Re: Indian Point Unit No. 2  
Docket No. 50-247

Attachment A to this letter provides our response to your February 25, 1982 request for additional information regarding our implementation of NUREG-0737 Item II.B.1, Reactor Coolant System Vents.

IMPLEMENTATION OF NUREG-0737 ITEM II.B.1  
REACTOR COOLANT SYSTEM VENTS.

RESPONSE TO FEBRUARY 25, 1982  
REQUEST FOR ADDITIONAL INFORMATION  
FOR INDIAN POINT 2

Figure 1

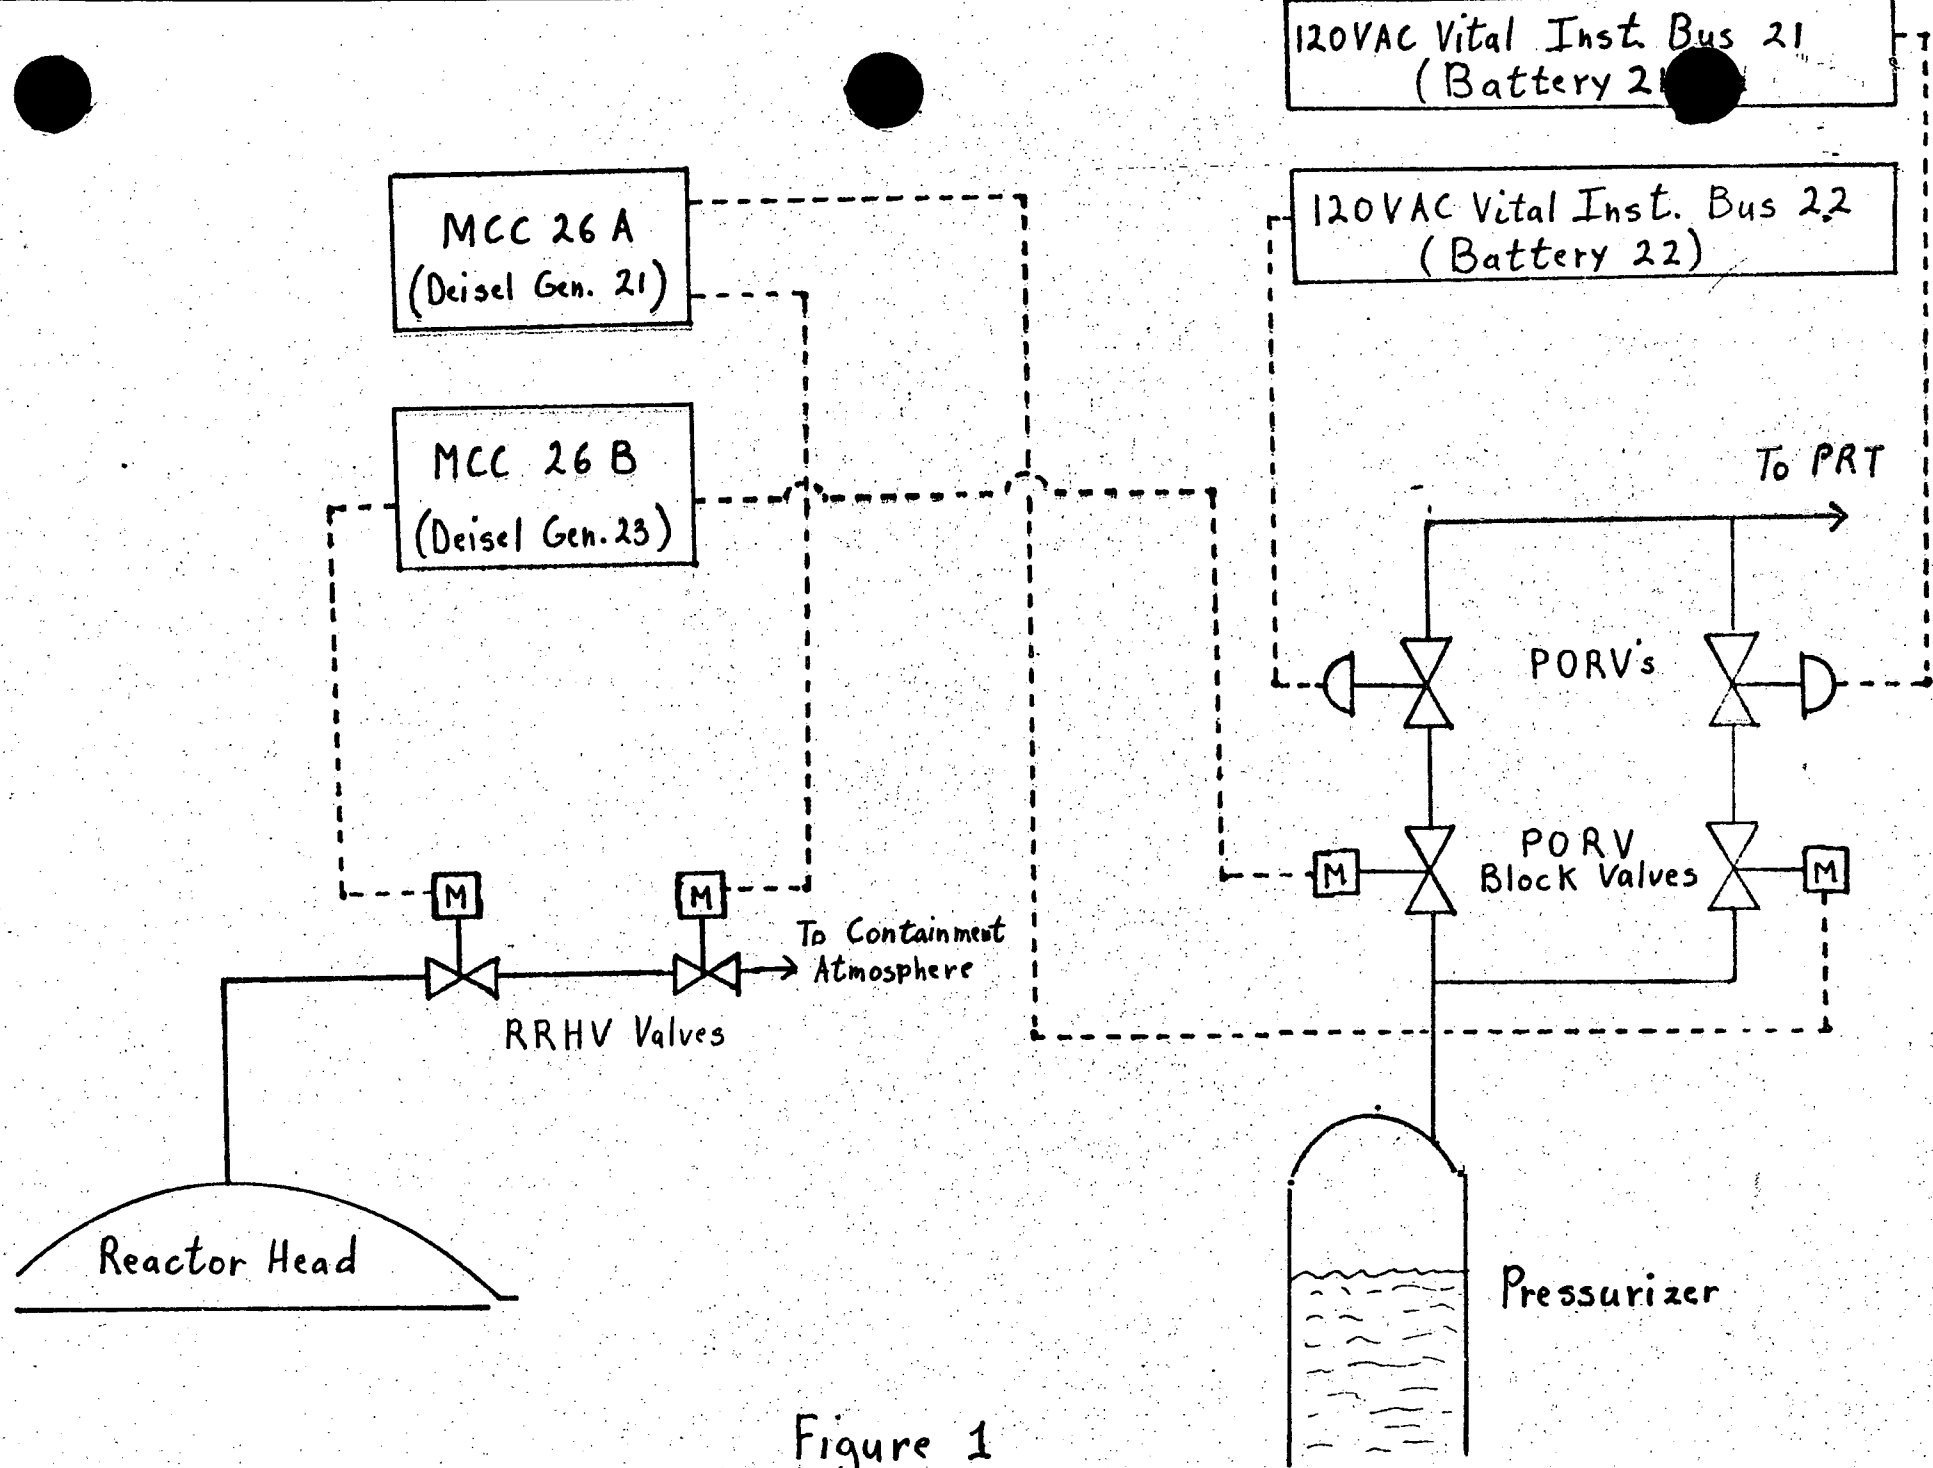
It is the NRC position that a degree of redundancy should be provided by powering different vents from different emergency buses (reference NUREG-0737 Item II.B.1 Changes to Previous Requirements and Guidance (4)). Since the PORV and block valves are required to be supplied with diverse emergency power sources, and the RRHV valves are supplied by diverse emergency power sources, a failure of one emergency power train could render both vent systems inoperable. Describe how the vent system will be modified to provide the necessary degree of redundancy (i.e., at least one vent path remains functional after the failure of one emergency power train) yet still prevent inadvertent or irreversible vent actuation.

As shown schematically in Figure 1, the RRHV valves and the PORVs and block valves are supplied with diverse and independent emergency power sources (indicated by parenthesis) such that: (a) at least one vent path remains functional after the single failure of an emergency power train, and (b) inadvertent or irreversible vent actuation cannot result from the malfunction of a single power train.
